FSC 22-18-2897 - 5 Tank Fairing Close out Bracket

Field Service Campaign

The CNG Pontoon Closeout Brackets may experience a fatigue failure and should be removed and replaced.

Rework Instructions for CNG Closeout Brackets 20-68822-007 & 20-68822-011 & Closeout Plate 20-68891-010

UPPER HOLE MODIFICATION

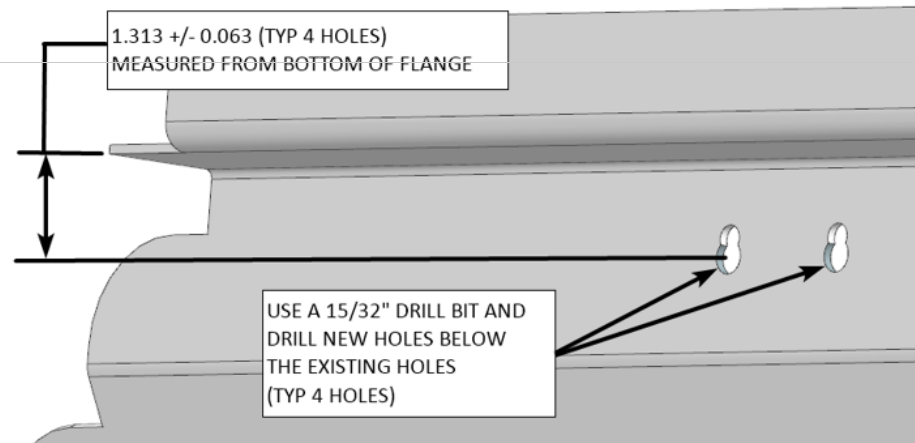
1. Place the closeout panel on a hard surface in the orientation shown in the lower left picture. Support the closeout as necessary to prevent deformation during the rework process.
2. Use a 15/32" drill bit to drill new upper mounting holes as shown in the picture on sheet 5
3. Use a 15/32" drill bit and enlarge the existing lower mounting holes. Drill new lower mounting holes (as shown on sheet 6) and then trim the material around the holes to make vertical slots.

LOWER HOLE MODIFICATION

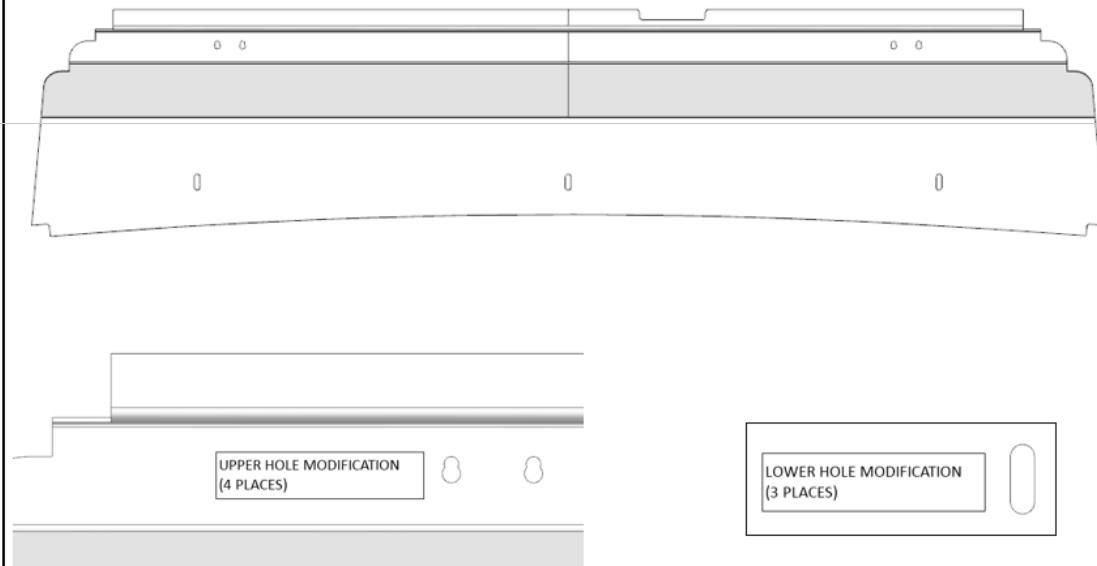
EXISTING HOLE
(TYP 3 LOCATIONS)

USE A 15/32" DRILL BIT TO ENLARGE THE EXISTING HOLE.
DRILL A NEW 15/32" HOLE BELOW THE EXISTING HOLE.
(TYP 3 LOCATIONS)

0.875 +/- 0.063 (TYP 3 LOCATIONS)

REMOVE THIS MATERIAL
TO FORM A SLOT
(TYP 3 PLACES)

FINAL SLOT
(TYP 3 PLACES)

STEP 4: Install new brackets.

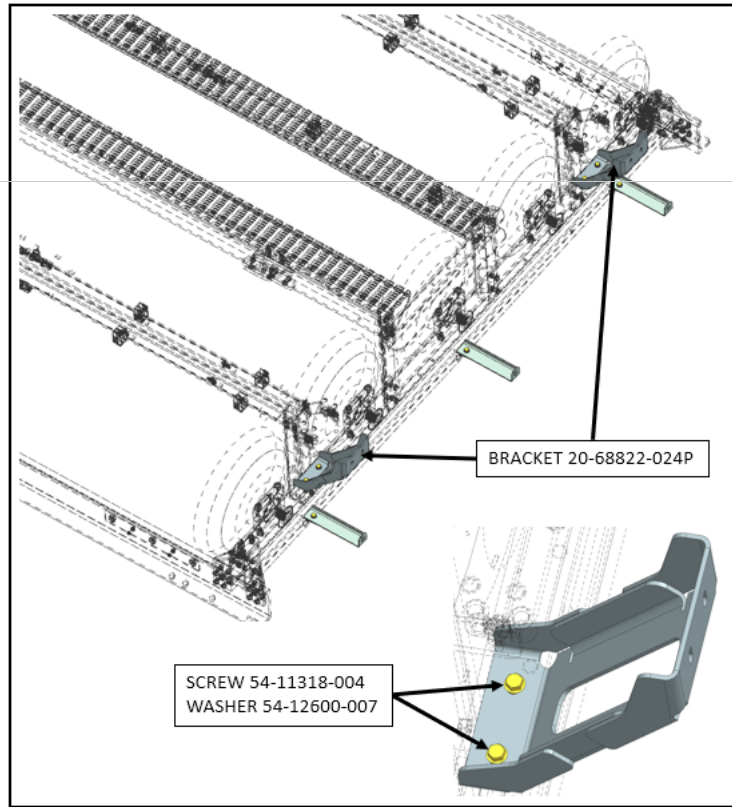
1. Install new two new brackets (P/N 20-68822-024P) in the same location as brackets 20-68822-007 and 20-68822-011 using 5/16-18 UNC x 1.25 cap screws (P/N 54-11318-004) and 5/16" SAE washers (P/N 54-12600-007).

2. Hand-tighten the screws only (to allow for adjustments during the closeout plate installation).

CURB SIDE UPPER MOUNTING HARDWARE

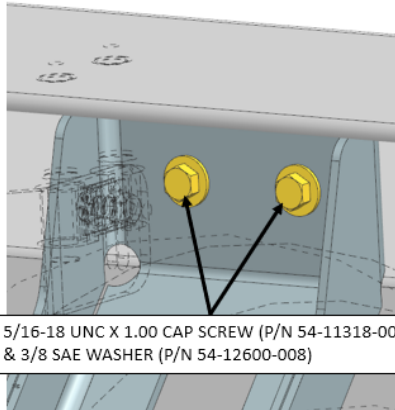
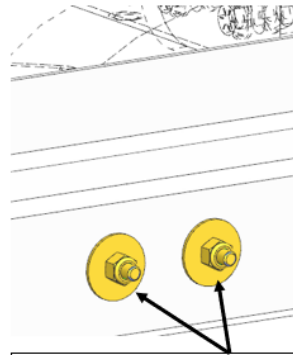
1. Place the modified closeout plate (P/N 20-68891-010) against the upper face of the new 20-68822-024P brackets.
2. Install the curb side upper mounting hardware into the large upper mounting holes that were drilled during the closeout plate modification.
The curb side bracket uses 5/16-18 UNC x 1.00 cap screws (P/N 54-11318-003), 3/8 SAE washers (P/N 54-12600-008), 5/16 fender washers (P/N 54-12605-003), and 5/16-18 UNC lock nuts (P/N 54-12540-006).

PLACE THE MODIFIED
CLOSEOUT AGAINST THE
UPPER FACE OF THE NEW
20-68822-024P BRACKETS

INSTALL THE UPPER MOUNTING HARDWARE IN THE NEW HOLES THAT WERE DRILLED IN THE CLOSEOUT PLATE DURING THE MODIFICATION PROCESS

5/16-18 UNC X 1.00 CAP SCREW (P/N 54-11318-003)
& 3/8 SAE WASHER (P/N 54-12600-008)

5/16-18 FENDER WASHER (P/N 54-12605-003)
& 5/16-18 UNC LOCK NUT (P/N 54-12540-006)

STREET SIDE UPPER MOUNTING HARDWARE

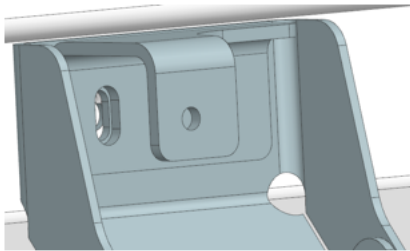
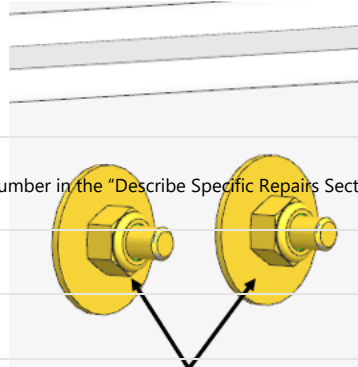
3. Adjust the position of the street side 20-68822-024P bracket as necessary to align all of the closeout plate mounting holes and slots.
4. Install new gas spring bracket 20-68822-025P on the street side 20-68822-024P bracket.
5. Install the street side upper mounting hardware into the large upper mounting holes that were drilled during the closeout plate modification.
The street side bracket uses 5/16-18 UNC x 1.25 cap screws (P/N 54-11318-004), 3/8 SAE washers (P/N 54-12600-008), 5/16 fender washers

PLACE NEW BRACKET 20-68822-025P ON THE STREET SIDE 20-6822-024P BRACKET

INSTALL THE UPPER MOUNTING HARDWARE IN THE NEW HOLES THAT WERE DRILLED IN THE CLOSEOUT PLATE DURING THE MODIFICATION PROCESS

5/16-18 FENDER WASHER (P/N 54-12605-003)
& 5/16-18 UNC LOCK NUT (P/N 54-12540-006)

STEP 5: Install closeout plate (continued)

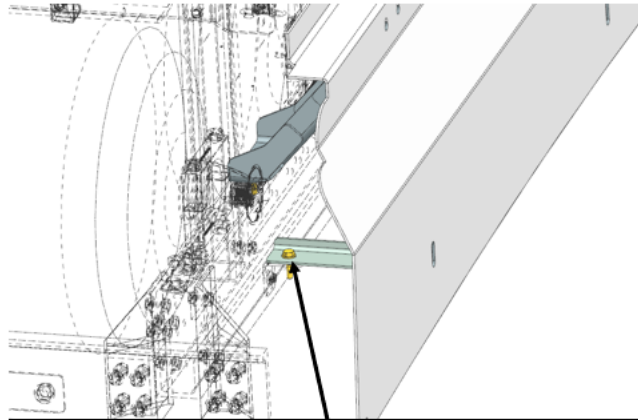
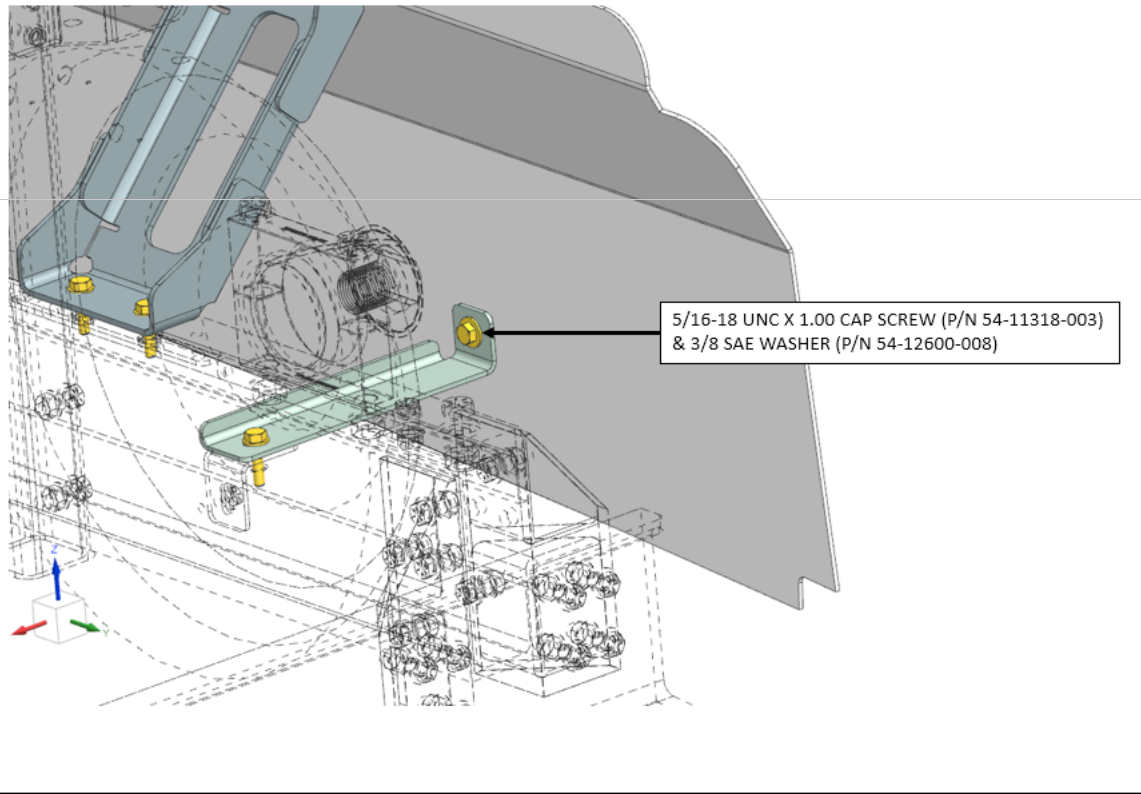
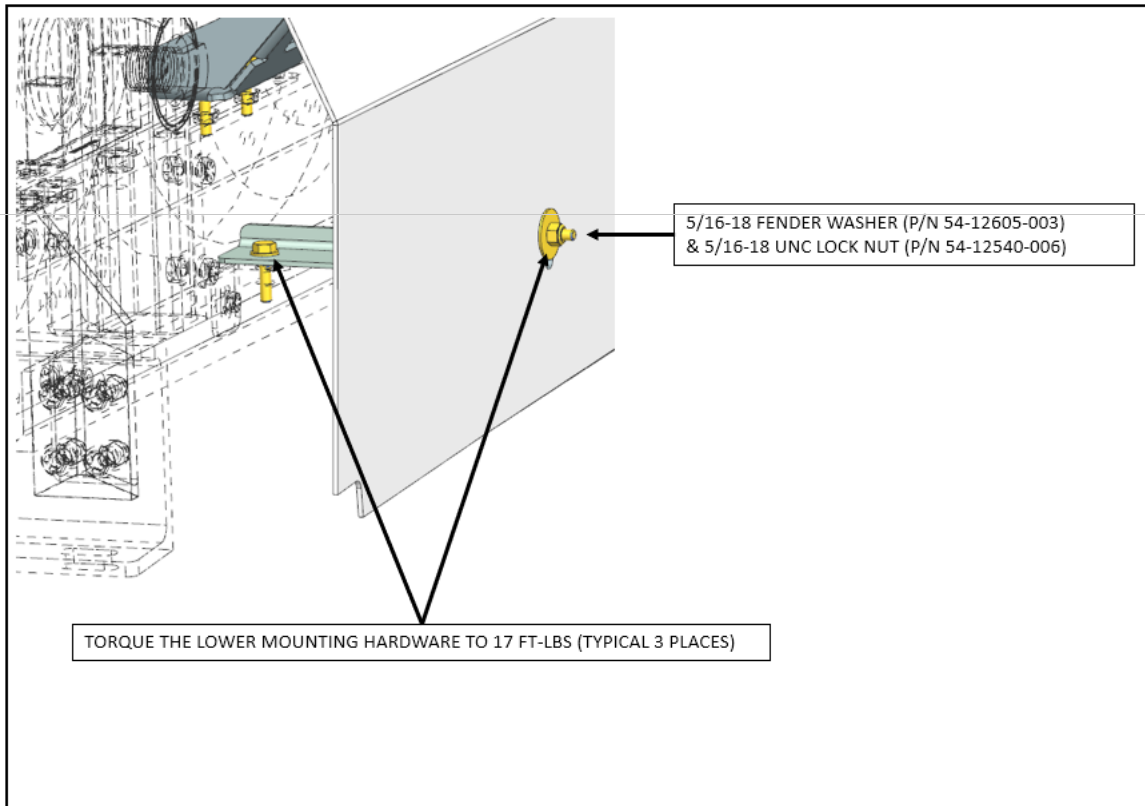
6. Tighten the upper mounting hardware to 17 ft-lbs torque (typical 4 places).

7. If required, loosen the lower bracket hardware and adjust the lower brackets as needed to align with the lower slots on the closeout plate.

8. Install the mounting hardware for the lower closeout mounting slots (typical 3 places). The lower mounting hardware consists of 5/16-18 UNC x 1.00 cap screws (P/N 54-11318-003), 3/8 SAE washers (P/N 54-12600-008), 5/16 fender washers (P/N 54-12605-003), and 5/16-18 UNC lock nuts (P/N 54-12540-006).

9. Tighten the lower bracket mounting hardware and the closeout lower mounting hardware to 17 ft-lbs.

TIGHTEN THE UPPER HARDWARE TO 17 FT-LBS

IF NEEDED, LOOSEN THE LOWER BRACKET HARDWARE AND ADJUST THE LOWER BRACKETS TO ALIGN WITH THE LOWER SLOTS IN THE CLOSEOUT PLATE (3 PLACES).

STEP 6: Install gas spring.

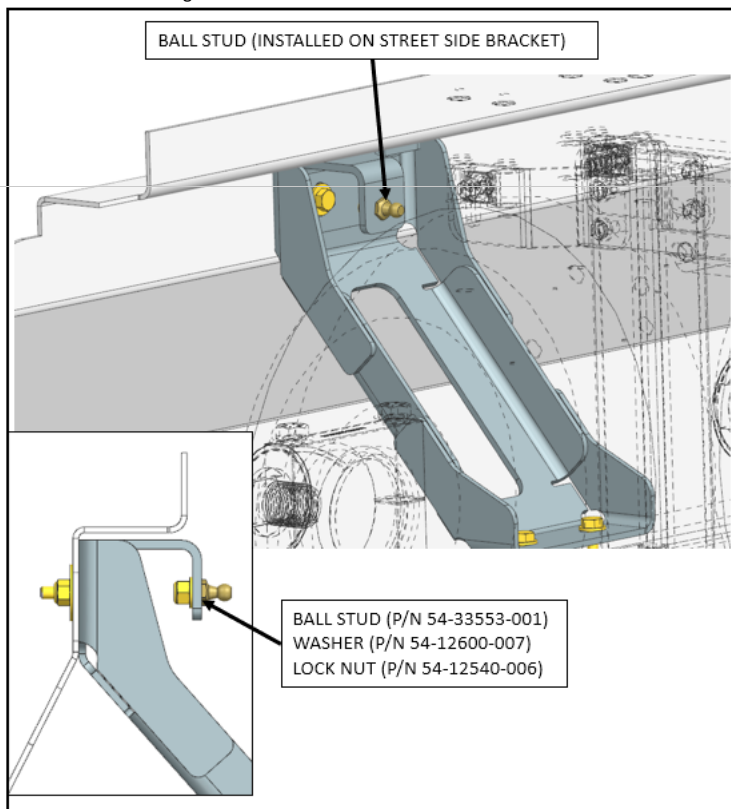
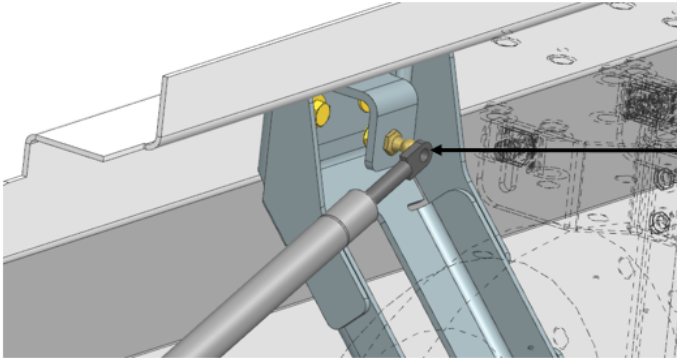
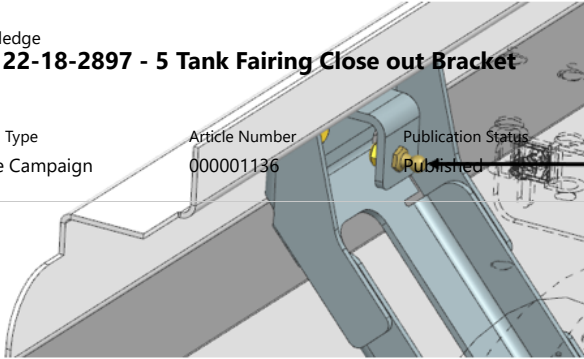
1. Install the ball stud (P/N 54-33553-001) onto the street side gas spring bracket (P/N 20-68822-025P). Include the 5/16 SAE washer (P/N 54-12600-007) and 5/16-18 UNC lock nut (P/N 54-12540-006).
2. Tighten the ball stud hardware to 17 ft-lbs.
3. Connect the forward gas spring (P/N 53-20347-XXX) to the ball stud.

12/23/2022 1:18 PM
TIGHTEN THE BALL STUD
HARDWARE TO 17 FT-LBS

ATTACH THE FORWARD STREET SIDE
GAS SPRING TO THE BALL STUD
